**Before the  
Federal Communications Commission  
Washington, D.C. 20554**

In the Matter of	)	
	)	
Space Exploration Holdings, LLC	)	File No. SAT-MOD-20200417-00037
	)	Call Signs S2983 and S3018
Application for Modification of Authority for the	)	
SpaceX NGSO Satellite System	)

**PETITION TO DENY OR DEFER OF SES AMERICOM, INC. AND O3B LIMITED**

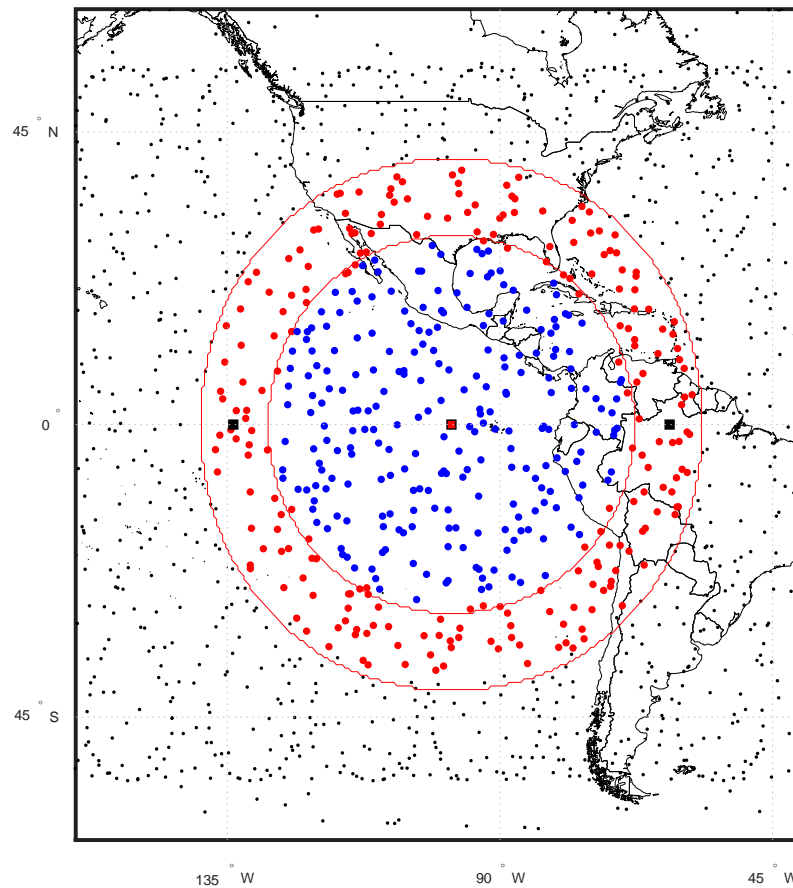
The following figure provides a snapshot of this effect. An O3b equatorial satellite is shown as a red square in the center of the figure, and the blue dots in the inner ring surrounding the square represent the SpaceX satellites with which conjunction events with the O3b satellite are possible under the current SpaceX network configuration. The red dots in the “donut” between the inner ring and the outer ring show the additional SpaceX satellites capable of creating a conjunction event with O3b if the changes proposed in the Application were implemented. As the O3b satellite moves over the equator, the “donut” will move as well, meaning that any part of CONUS below roughly  $41^{\circ}$  N.L. will be within the area in which new inline events would be made possible by the SpaceX changes.

These additional conjunction events will create interference concerns for O3b in both the uplink and downlink directions. The attached Technical Annex quantifies the impact on O3b. Specifically, O3b performed a simulation to calculate the duration of inline events with O3b's constellation using the characteristics of the currently authorized SpaceX system and the system as modified by the changes discussed in the Application. The simulation showed that the changes requested in the Application would increase both the number and persistence of inline events with O3b, more than quadrupling the total duration of such events as compared to what would occur with the currently authorized SpaceX system. Specifically, the data show that the O3b constellation is 434% more likely to experience a conjunction event with a SpaceX satellite under the proposed modification.

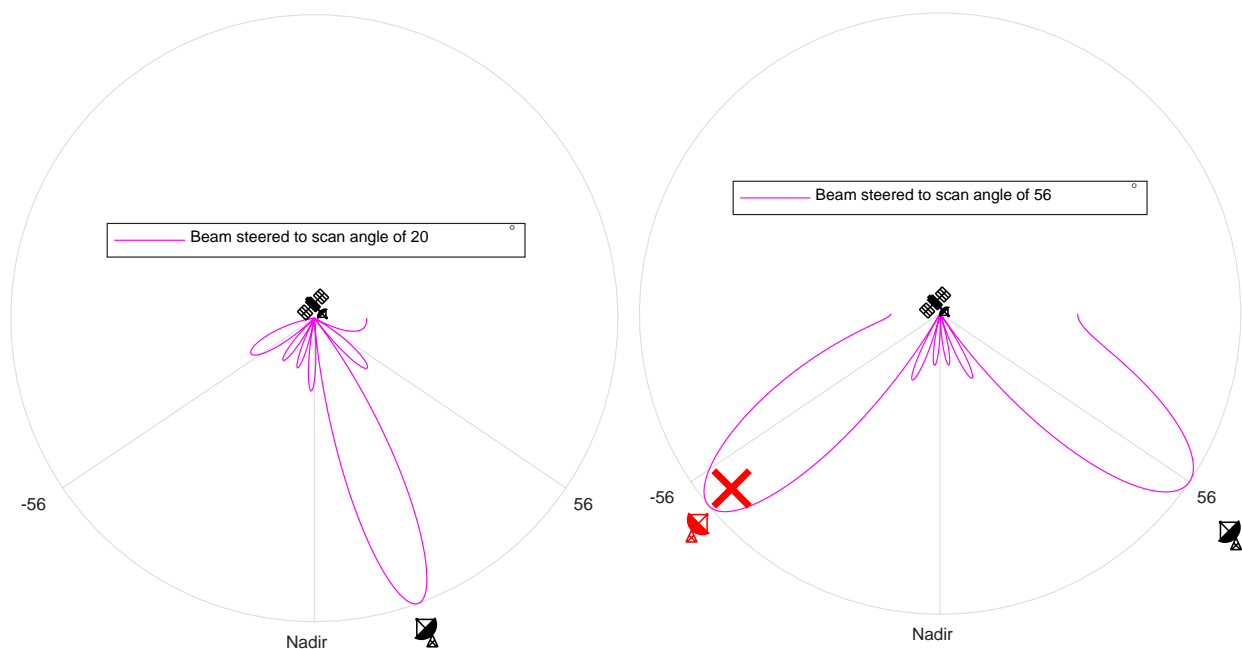
As discussed in the attached Technical Annex and depicted in the figures below, an electronically formed and steered beam can have grating lobes that appear unintentionally at far-off angles from boresight but at gain levels comparable to the main lobe. The figure on the left shows a satellite beam pointing at a scan angle of 20 degrees from nadir, which is well formed with no apparent grating lobes landing on the Earth. However, if this same antenna is steered to a scan angle of 56 degrees away from nadir, a second beam can appear at an angle well removed from the desired boresight. The O3b victim earth station shown in red on the figure to the right below may experience interference even though it is located a significant distance from the target SpaceX earth station.

The Application does not discuss the operational impact of the proposed increase in scan angles for the SpaceX satellite antennas or indicate whether SpaceX has taken any steps to evaluate the potential for interfering grating lobes or mitigate their effects. These deficiencies further undermine SpaceX's arguments that its proposed changes will not harm other operators.

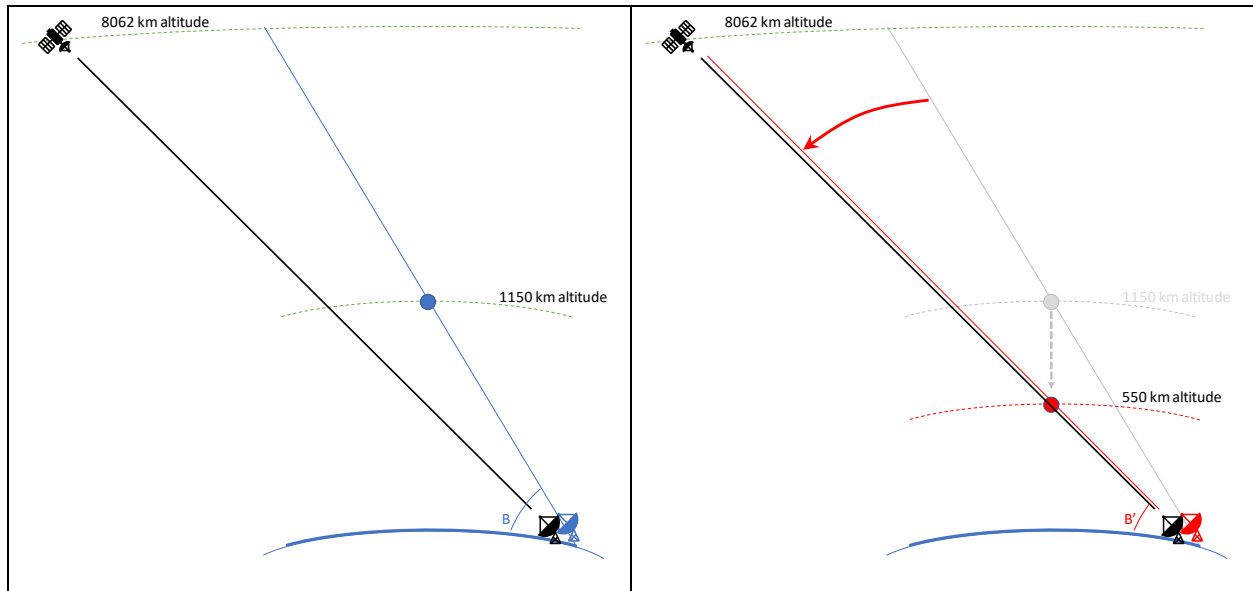
The figures below illustrate a SpaceX earth station being served by an original-altitude satellite at 1150 km compared with a proposed-altitude satellite at 550 km. In the figure on the left, the geometry makes it impossible for the SpaceX earth station and satellite pair to have a conjunction event with an O3b satellite at 8062 km serving an earth station collocated with or close to the SpaceX earth station. However, at the lower SpaceX satellite altitude, the geometry changes and produces a conjunction event

between the SpaceX and O3b satellite-earth station pairs. The effects of the change on the O3b interference environment are discussed below.

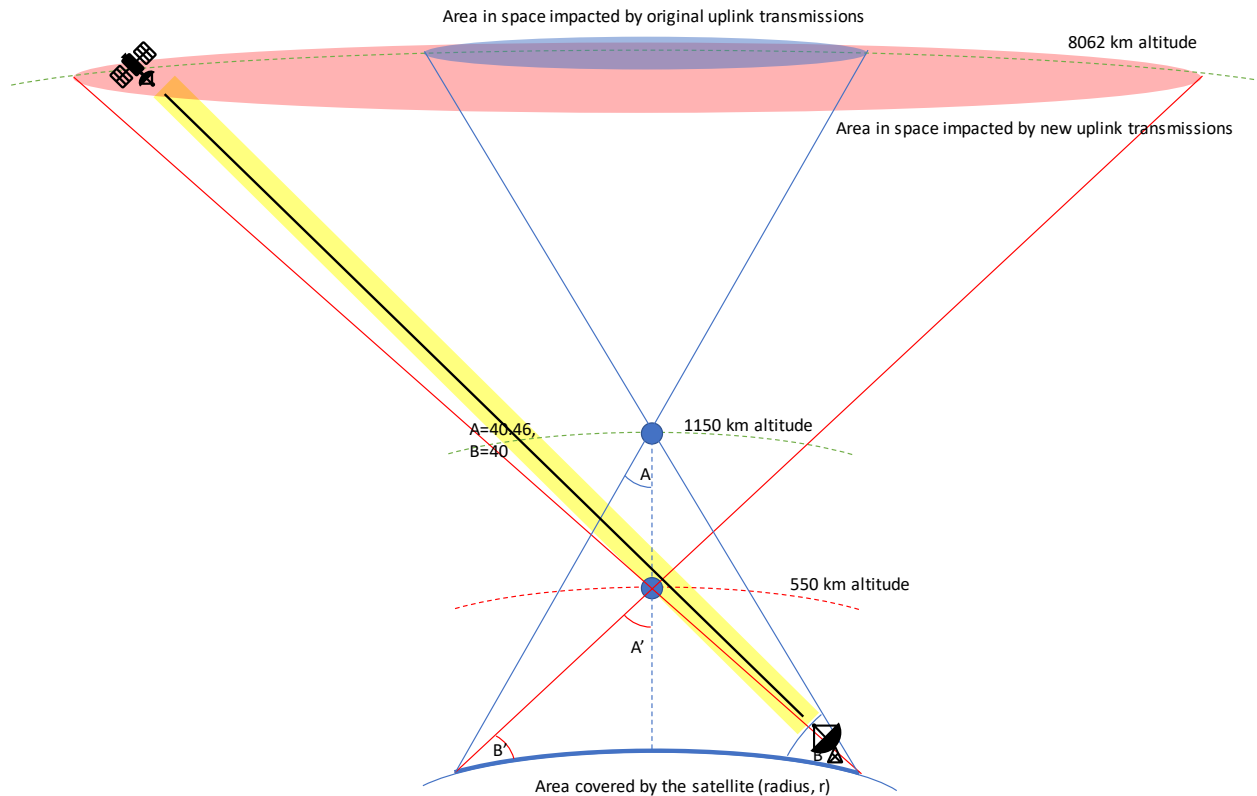
Expanding this example to consider all possible geometries, the following graphic illustrates the increased interference area into (and from) O3b satellites and their associated earth stations associated with the lower SpaceX satellite altitude and earth station elevation angle. This two-dimensional graphic is intended to show a three-dimensional issue since the hourglass figures depicted are actually three-dimensional cones. The areas on Earth and in space within which a potential inline event could occur with the currently authorized SpaceX system configuration are outlined in blue, and the areas subject to an inline event with the proposed modified SpaceX configuration are outlined in red. Any O3b satellite that might appear in the red area could experience conjunction events with a SpaceX satellite-earth station pair based on the modified geometry resulting from the changes in the Application, with a potential for interference impact in both the uplink and downlink directions.

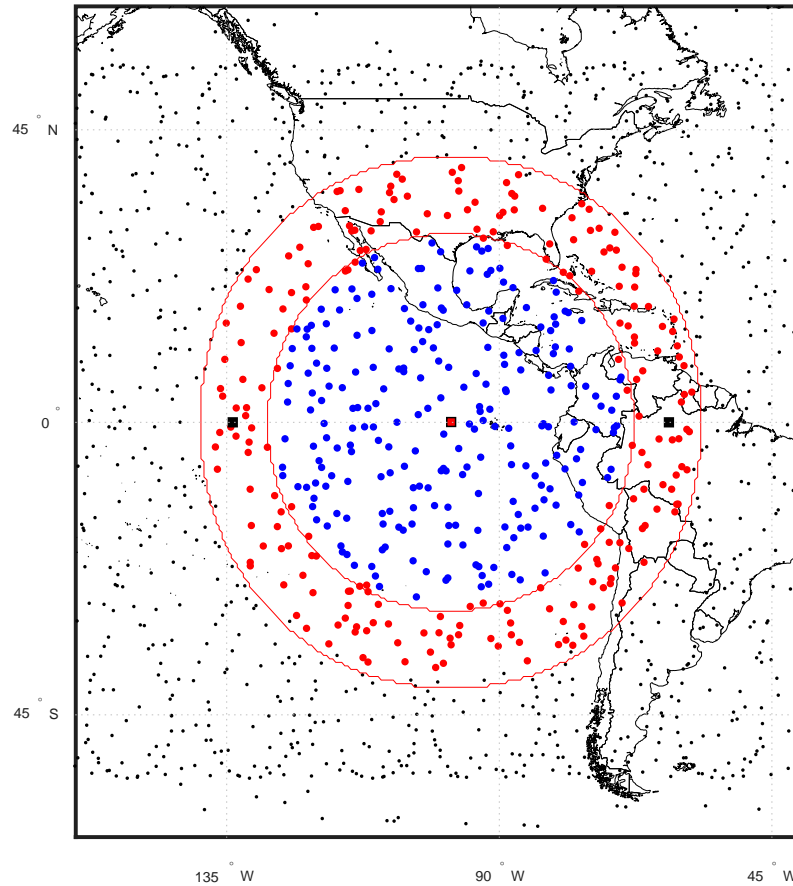
SES next maps the area where new conjunction events between SpaceX and O3b could occur due to the changes proposed in the Application. In the figure below, the O3b satellite at 0°N latitude is indicated by a red square, and the two solid red circles represent earth station elevation angles of 40 degrees and 25 degrees. The blue dots within the inner red ring depict SpaceX satellites that could be involved in an inline event with the O3b satellite assuming the minimum elevation angle for SpaceX earth stations is 40 degrees. The red dots between the two rings represent SpaceX satellites that could generate inline events with the O3b satellite under the changed configuration proposed in the Application, with SpaceX using lower satellite altitudes and decreasing the minimum earth station elevation angle to 25 degrees. In this snapshot, the number of “original interfering satellites” (blue) is 210 while the number of “new interfering satellites” (red) is 224 – a 106% increase in possible interference cases for this O3b satellite. Thus, the system configuration changes SpaceX is seeking will produce a 106% greater likelihood of inline events with O3b and a corresponding 106% potential increase in amplitude of the aggregate interference received at the O3b satellites.

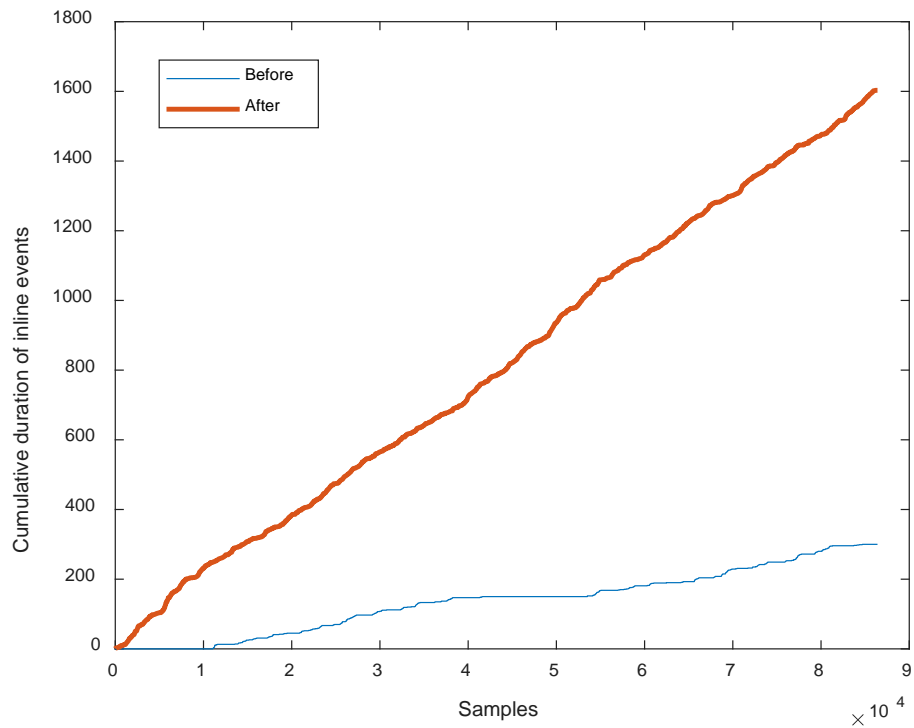
The green points in the figures below represent instances when the minimum separation between a SpaceX and O3b satellite is greater than the 5-degree threshold considered for purposes of this analysis to qualify as a conjunction event. The red points represent instances when the minimum separation angle is less than 5 degrees, signifying a conjunction event.

The figures show that the changes requested in the Application would significantly increase the inline events. In the Before case, the simulation showed that the O3b earth station would be subject to inline events lasting a total of 300 seconds. In the After case, the O3b earth station would be subject to inline events lasting a total of 1603 seconds. This is further illustrated in the following figure depicting the cumulative duration of inline events over the 24-hour sample time for the Before and After cases.

Thus, SpaceX's proposed system modification would increase both the number and persistence of conjunction events experienced by the O3b link, producing a 434% jump in the total duration of such events. As a result, O3b's efforts to avoid interference with SpaceX under the modified configuration would more than quadruple over that required with the existing SpaceX system design.

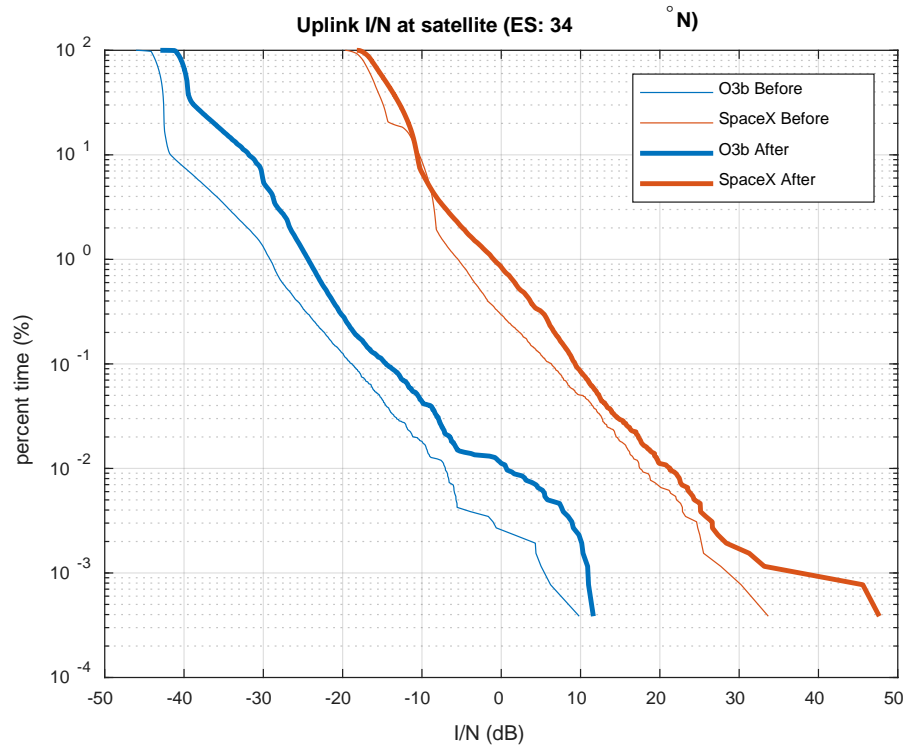
In the uplink direction, the analysis showed a significant harmful impact on O3b. For purposes of its analysis, SES referred to the information available in SpaceX earth station applications on file with the Commission to determine the parameters of the SpaceX uplink emissions. The power levels requested in these recent applications are consistent with those sought in prior SpaceX earth station filings, suggesting that despite statements in the Application about the possibility of using less power to communicate with

satellites at a lower altitude, SpaceX intends to operate its gateway earth stations at the same power levels it has been using to date. The simulation results based on these values show that the changes sought in the Application would cause a significant and persistent increase in interference to the O3b satellites. At the 0 dB I/N point (when SpaceX interference is equal to the O3b system noise), there is a 400% increase in the interference potential. In all cases, the I/N is worse, by significant amounts, for both O3b and SpaceX.

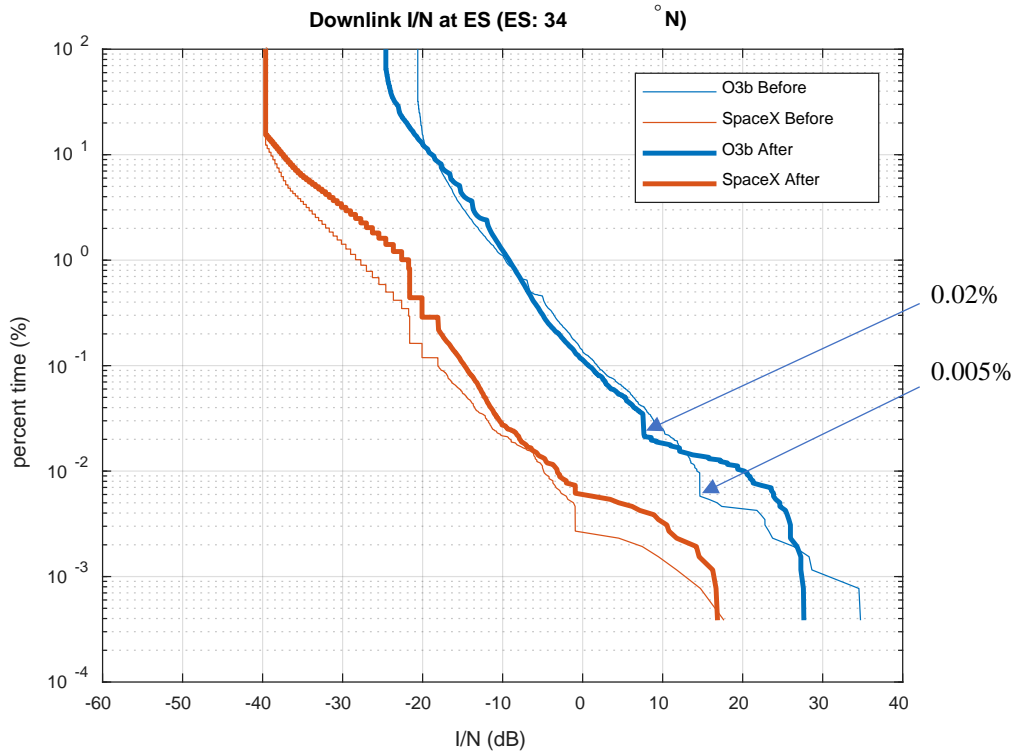
The simulation also showed that the O3b satellite downlink would experience more interference in the short term due to a higher likelihood of main-lobe events created by the proposed modification (changing from 0.005% to 0.02%). Although the probability is still low, this change represents a 300% increase in the likelihood of short-term interference to O3b from the SpaceX operations. This impact is especially meaningful because it represents only the SpaceX contribution to the total interference O3b experiences – multiple other NGSO constellations could also create interference into O3b’s operations. The long-term potential for downlink interference to O3b is roughly the same or better in the After case due to SpaceX reducing its peak downlink PFD by approximately 6 dB.

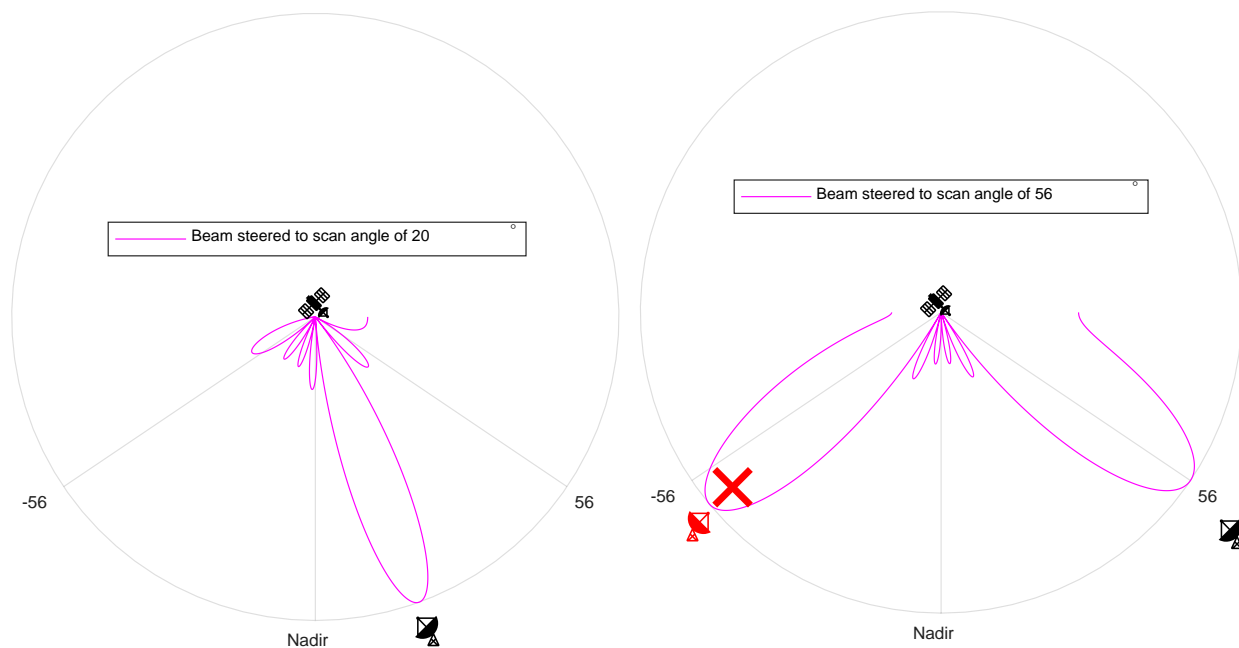
The figures below illustrate this issue. A satellite pointing at a scan angle of 20 degrees from nadir, such as the one shown on the left, generates a well-formed beam with modest sidelobes but no grating lobes that would land on the Earth's surface. At higher scan angles, however, a second beam can appear at an angle significantly offset from the desired boresight, as in the figure on the right. The O3b victim earth station depicted in red on that figure could be subject to interference even though it is located a significant distance from the target SpaceX earth station.

Based on the SpaceX system design description in the Application, SES understands that SpaceX will employ phased array antennas for both its Ka-band and Ku-band operations, creating the possibility of grating lobes that could increase the aggregate interference received at any Ka-band or Ku-band earth station communicating with an SES satellite. If the grating lobe gain is comparable to that of the main lobe, this could also create conjunction events between the grating lobe of the SpaceX system and a link between an O3b space station and earth station pair.

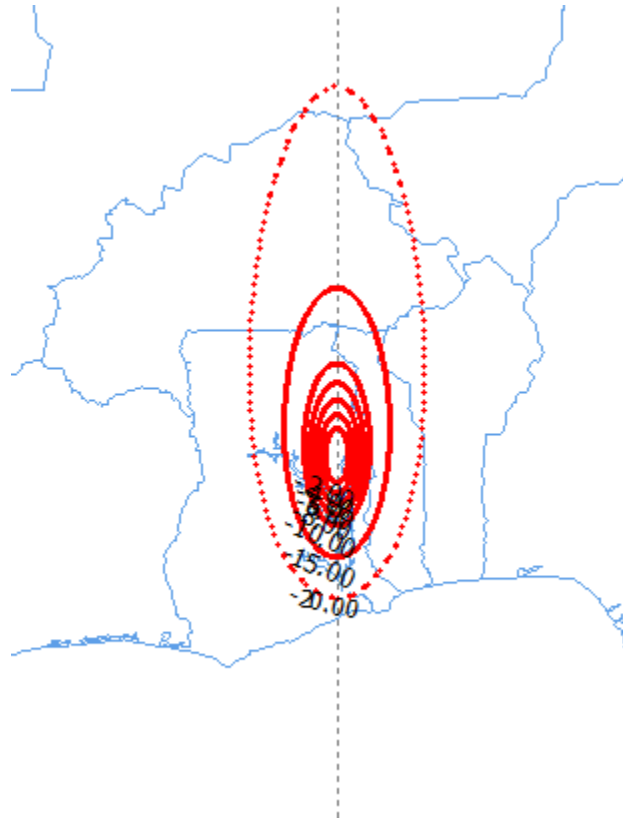
beam coverage information showing data in GIMS format. The figure below illustrates the KA\_PHI57 beam diagram supplied by SpaceX.

The SpaceX figure shows the intended beam contours, but the area within the visible range of the space station antenna is much larger. In the illustration below, SES recreated a beam contour based on the SpaceX example shown above but placed it over the United States. The beam is pointed with a 56-degree scan angle away from nadir, consistent with the parameters in the Application, and the figure shows the entire area visible to the satellite.
